Environmental Impact Statement

ERATTA NO. 01

N4 Collooney to Castlebaldwin Proposed Road Development

Figure No.:
Fig.: 8.1.1
Sheet 1 of 8

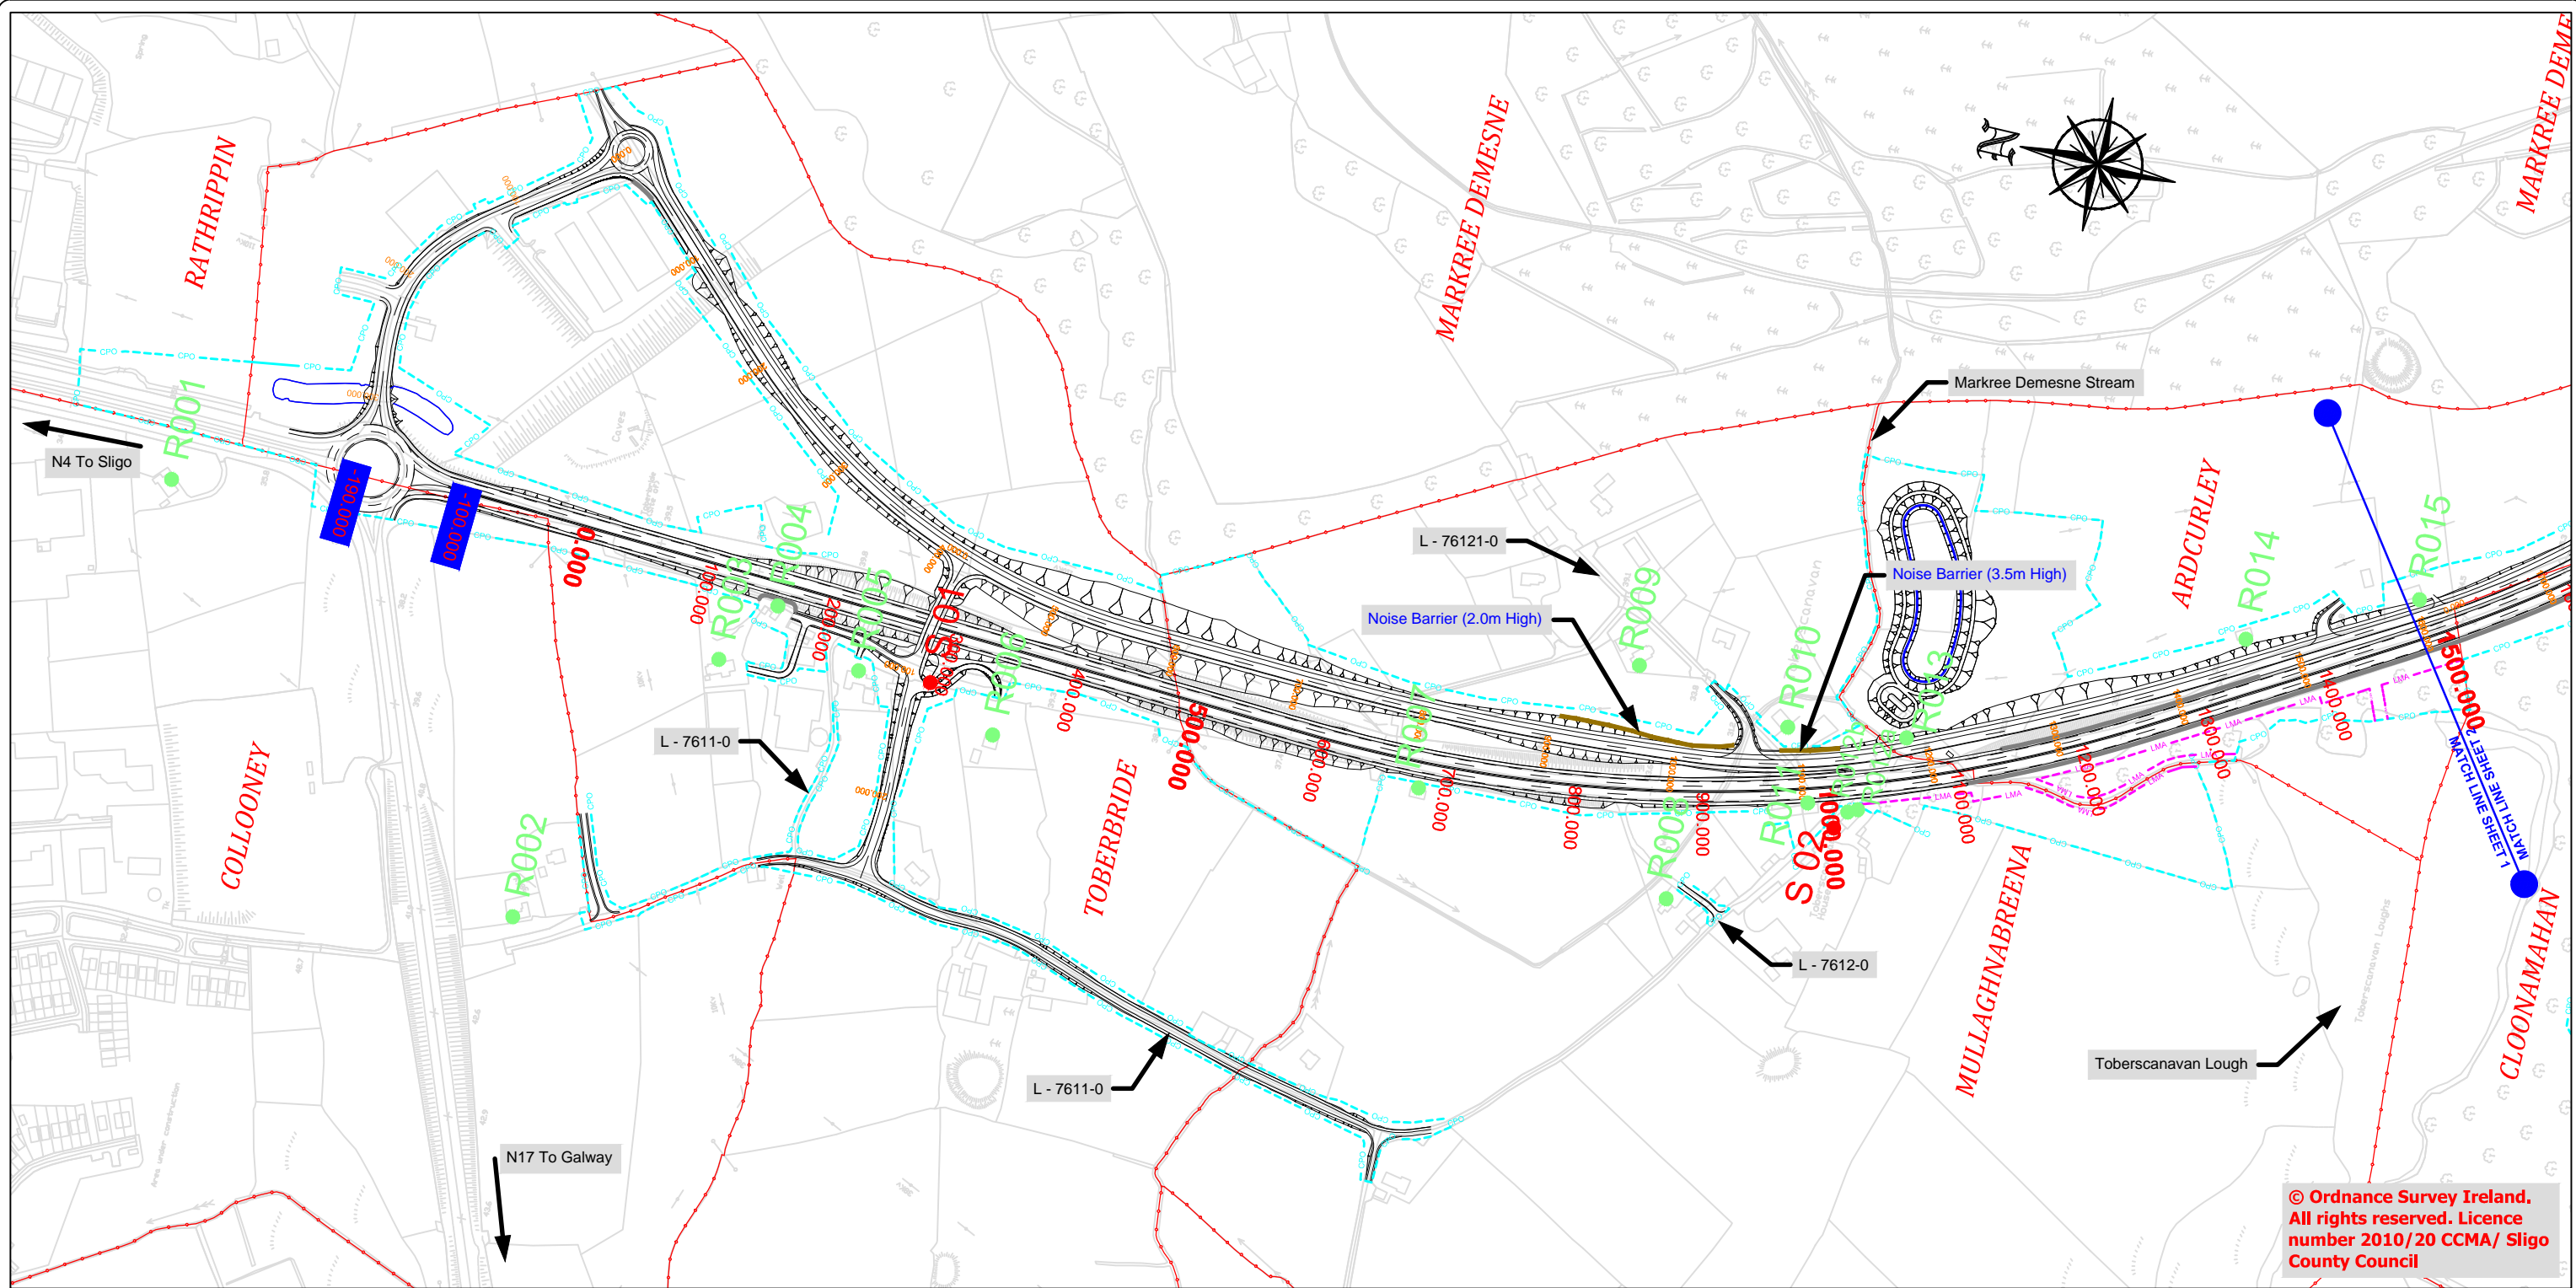
Figure 8.1.1

An additional noise mitigation barrier is provided to reduce noise impacts on receptor R009.

Date	By	Revision
April 2014	FM	This is an eratta to the EIS as described in Eratta Sheet No. 01.
		An additional barrier is provided to mitigate impacts to R009

Figure No.: Fig.: 10.1.1
Sheet 1 of 8

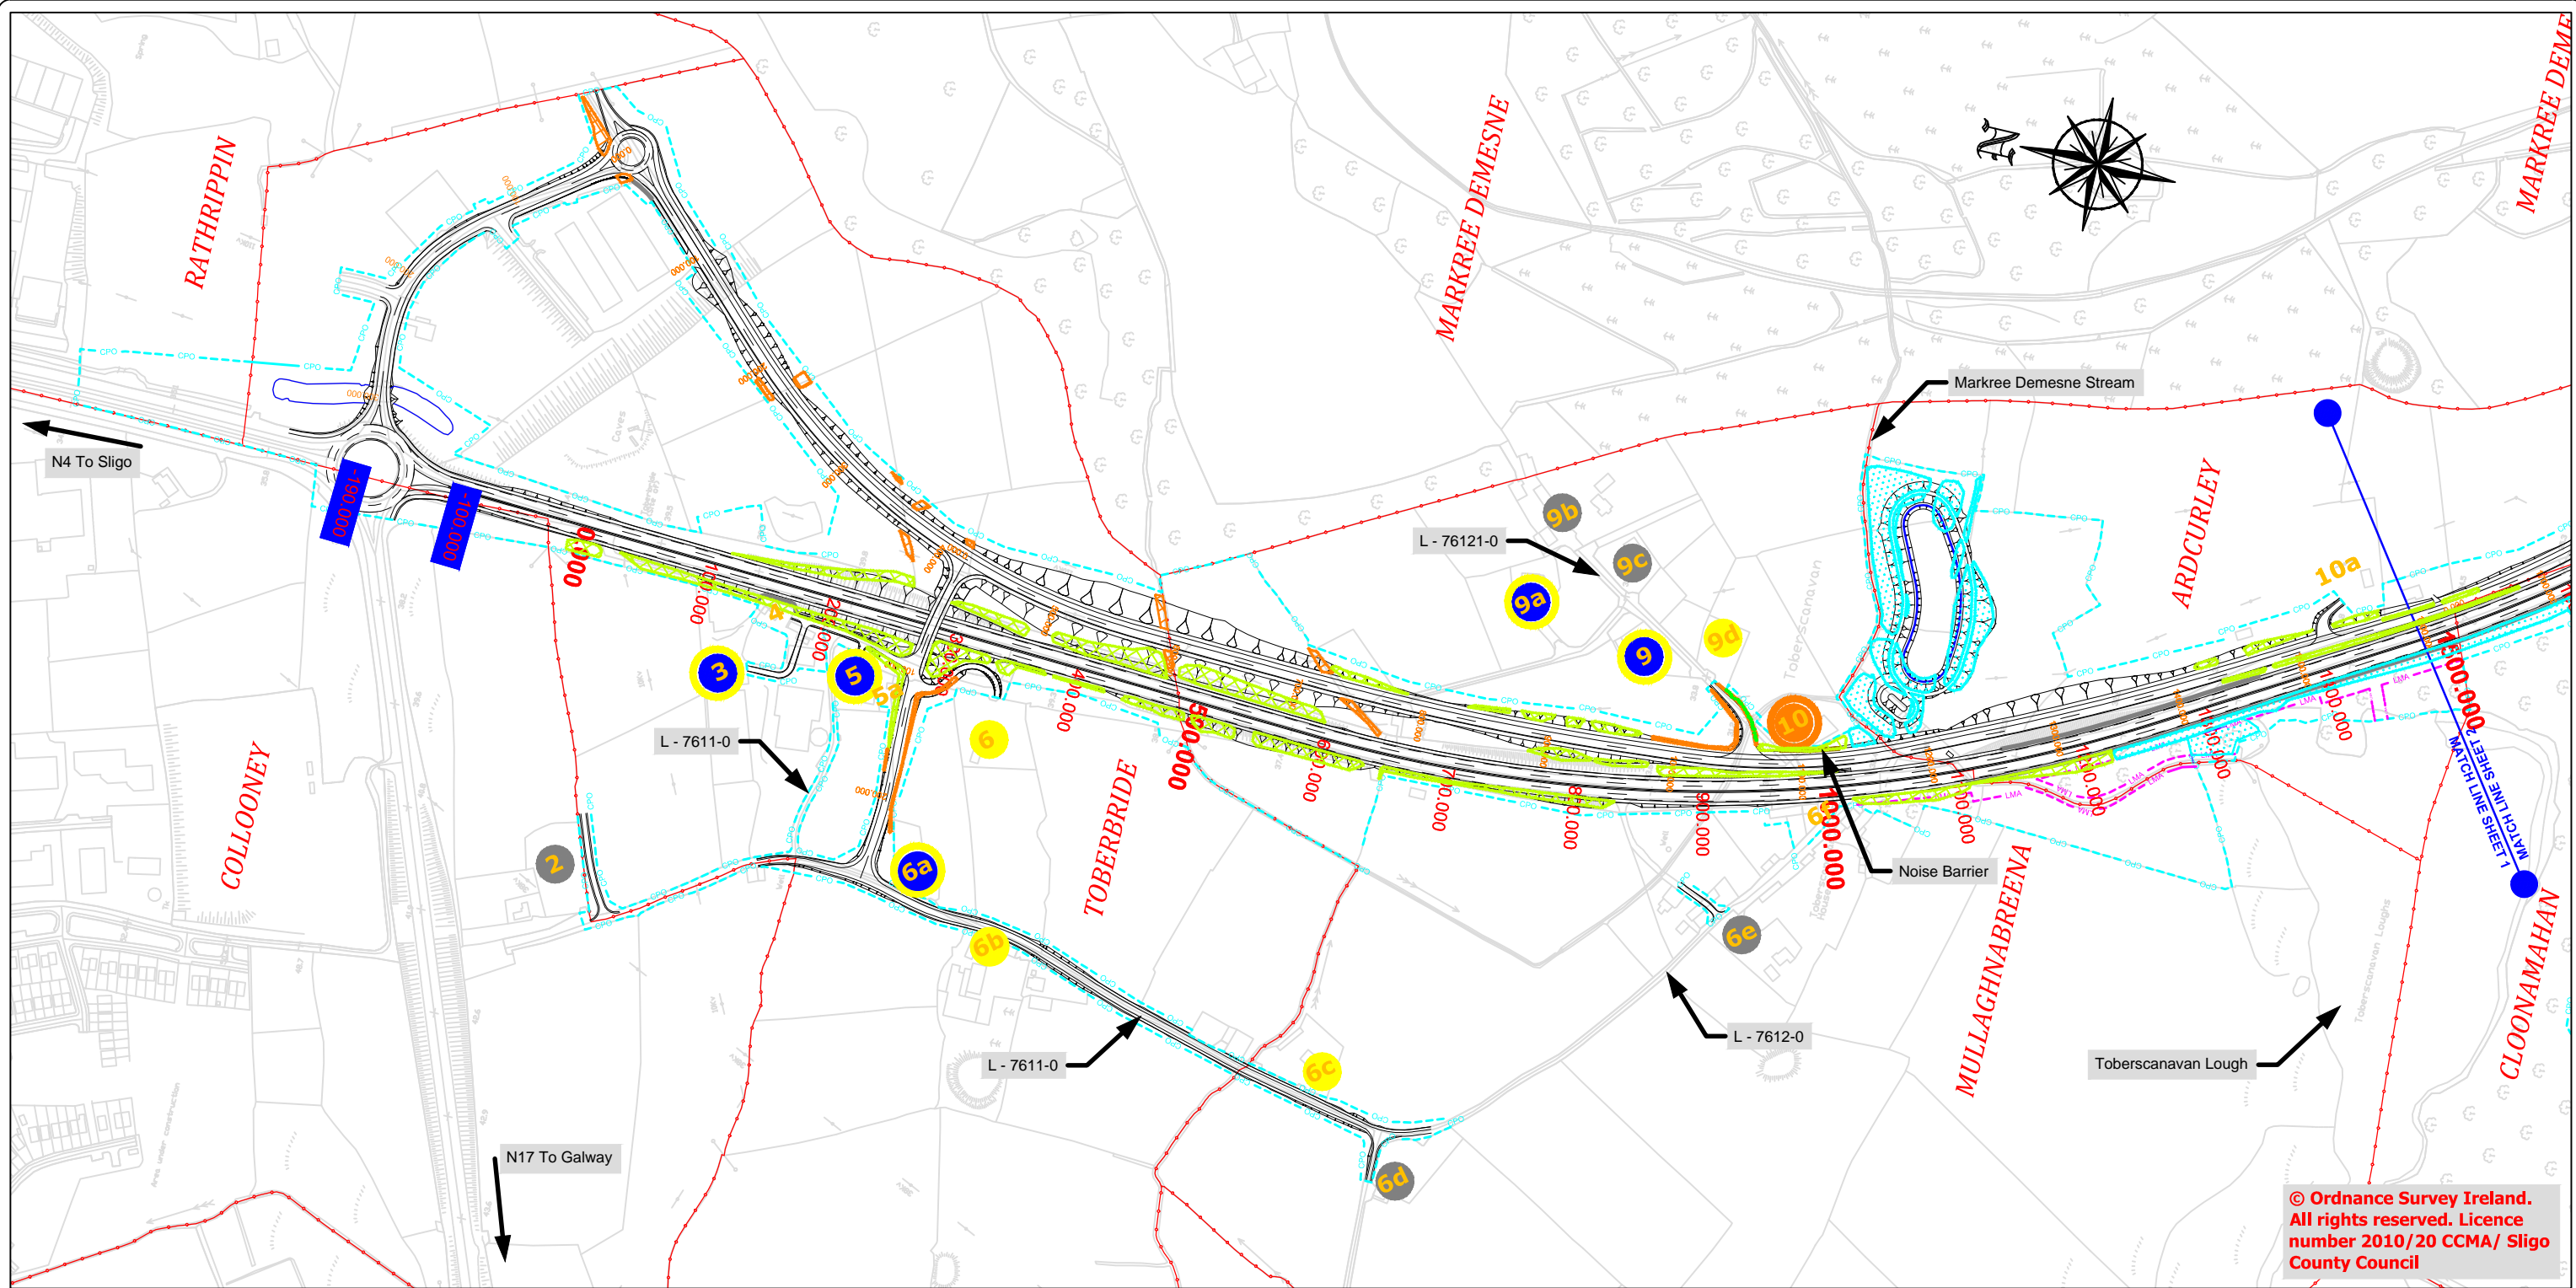
Figure 10.1.1

Receptor 10a at c. Ch. 1,450m is removed from the map. This is a printing error and is not referenced to in the EIS.

Date	By	Revision
April 2014	FM/CW	This is an eratta to the EIS as described in Eratta Sheet No. 01. Receptor 10a at c. Ch. 1,450m is removed from the Map.

Figure No.:
Fig.: 10.1.5
Sheet 5 of 8

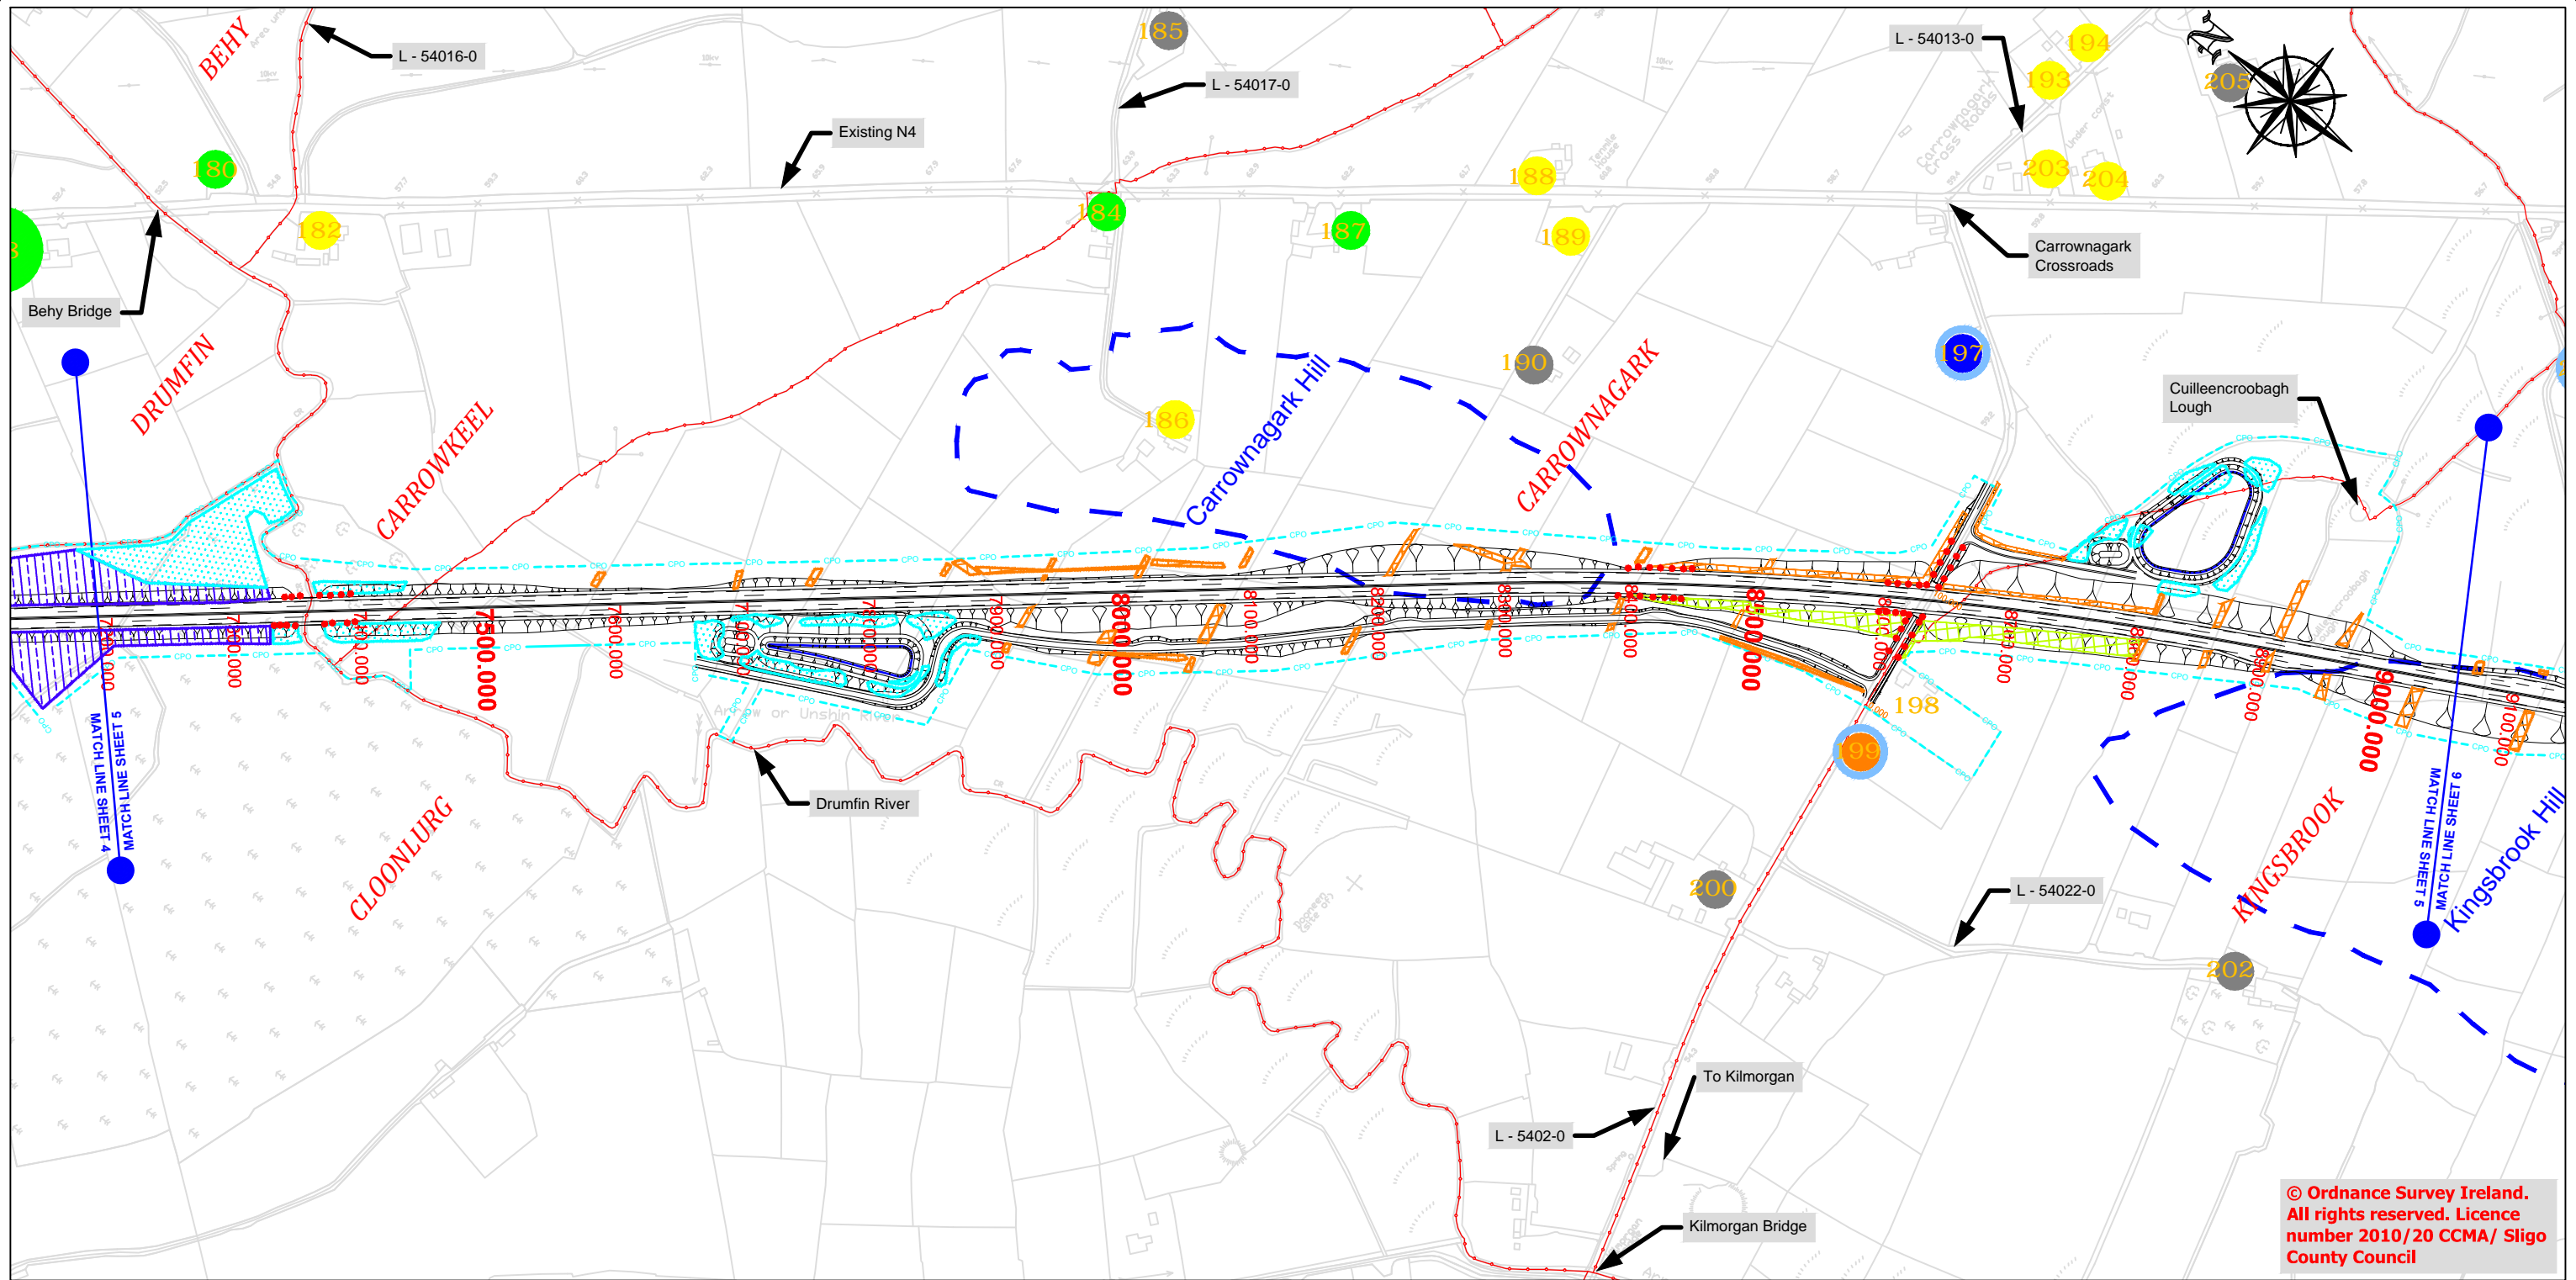
Figure 10.1.5

This map extends alluvial wet woodland planting to increase compensatory measures for the Flora, fauna and Fisheries Chapter.

Date	By	Revision
April 2014	FM/CW	This is an errata to the EIS as described in Errata Sheet No. 01. The Riparian woodland mix is extended in the vicinity of the Drumfin River crossing.
